Building: Senior Citizen Center

Project Description: Replacement Senior Citizen Center Construction

RE: Change Order #40 **fully executed**

**LEXINGTON-FAYETTE URBAN COUNTY  
GOVERNMENT CONTRACT CHANGE ORDER**

**SKA-126**

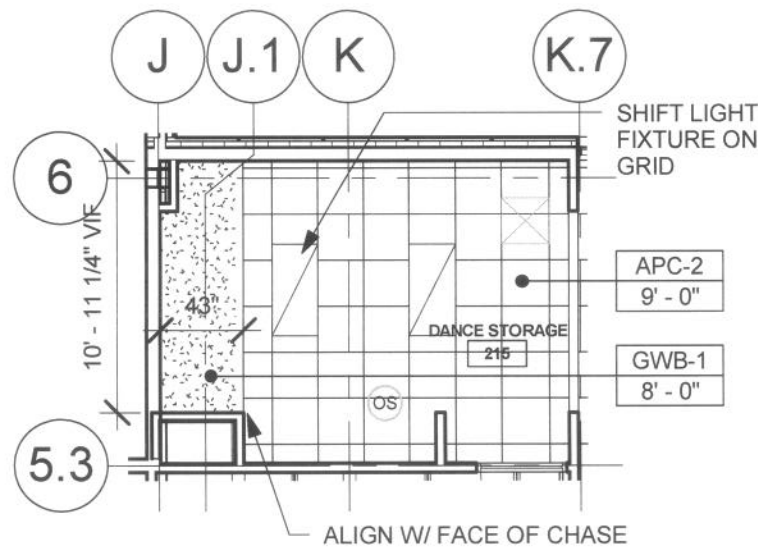
1. Necessity for change: Designed ceiling height conflicts with HVAC ductwork in Dance Storage. Adding a soffit will conceal the ductwork. Flooring installer recommended adding the passive air grilles and underlayment to increase air circulation under the floor and to protect the wood flooring. Plywood is more resilient than drywall and is more appropriate for an exterior storage space.

To avoid conflict with HVAC ductwork, please furnish a painted GWB soffit per the attached sketch. Please verify all dimensions prior to fabrication.

**SKA-127**

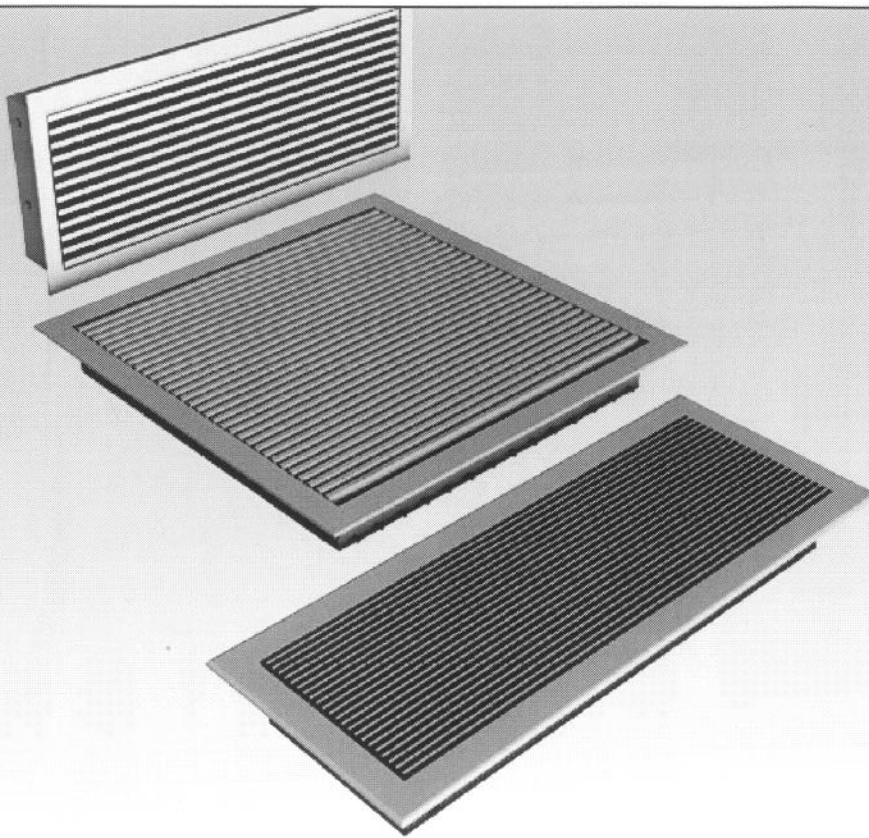
Per recommendation from the flooring subcontractor, please furnish and install the following improvements for the platform flooring:

- Lay 20 mil minimum plastic nonwoven membrane sheet at the floor slab to inhibit moisture infiltration into the plenum
- Install (2) displacement floor grilles as shown on the attached sketch for adequate air movement in the plenum. See basis-of-design product data in attached documents. Install blocking as required to adequately support floor grilles for normal traffic. Install between floor support studs; do not cut floor support studs to install (dimensions on the attached sketch are suggestions; locate as near

DISPLACEMENT FLOOR GRILLE, TYP  
 -INSTALL PER MANUFACTURER'S INSTRUCTIONS  
 -WOOD BLOCKING AS REQUIRED TO MATCH ROUGH OPENING BETWEEN FLOOR SUPPORTS  
 -FIN LAYOUT AND FINISH PER SPEC SHEET
